SERVICE BULLETIN

NUMBER: DCI-A119-IBF-SB01
Date: 08 June 2021

SUBJECT: BACKSHELL FASTENER REPLACEMENT

Leonardo Helicopters - Models: A119, AW119MKII (STC SR02338CH) (SN 0001 & SUBSQ)

Figure 1 – Location of Backshell Screws Recommended for Replacement

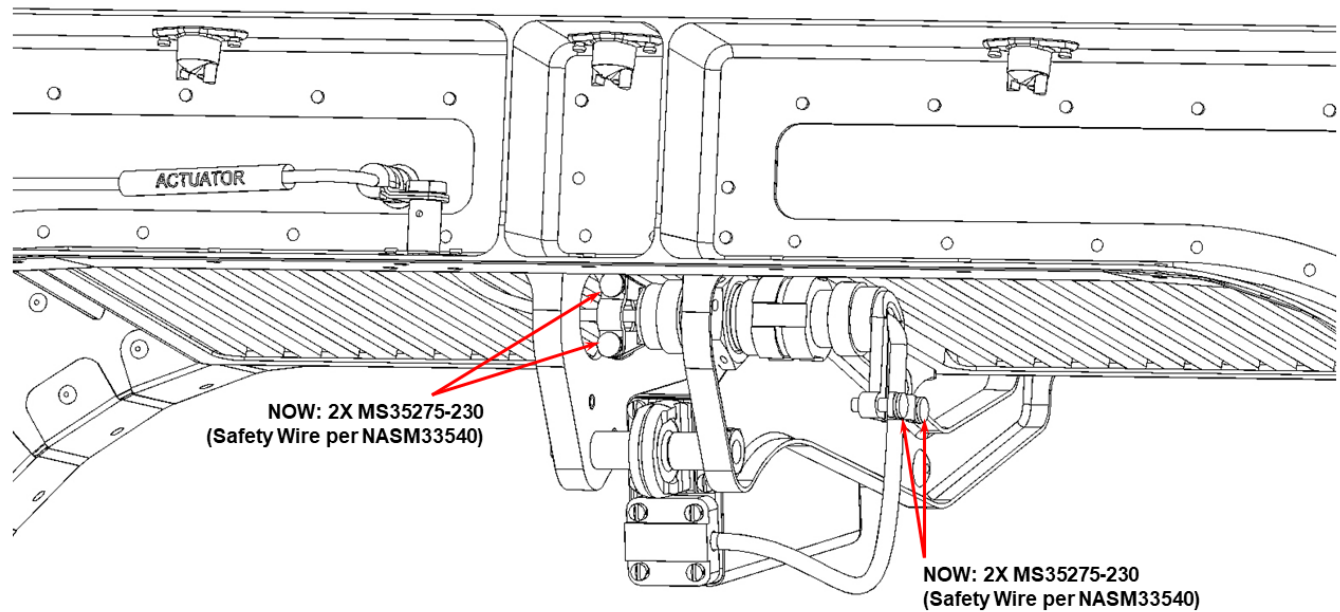
This is not a safety of flight issue, if operators follow Section 8.5.6.2 of the Instructions for Continued Airworthiness (ICA) and verify that Backshells are secure during regular maintenance intervals, then it is highly unlikely that the Backshell fasteners will come loose during flight. Nonetheless, Donaldson recommends a product improvement for all operators of the DCI AW119 IBF by replacing the existing fasteners on the Backshell of the 119400-101 Wire Harness connecting to the linear actuator & the Backshell of the linear actuator (106113-203) with MS35275-230 screws and to safety wire the screws per NASM33540. Location of these screws can be found depicted in Figure 1. Inspection requirements for the Backshells will remain the same unless otherwise directed by a newer revision of the ICA (Reference 1).

Operators are recommended to locally procure the replacement hardware as applicable. If local procurement is not available, operators can procure the screws from Donaldson's ecommerce site found in the Contact section.
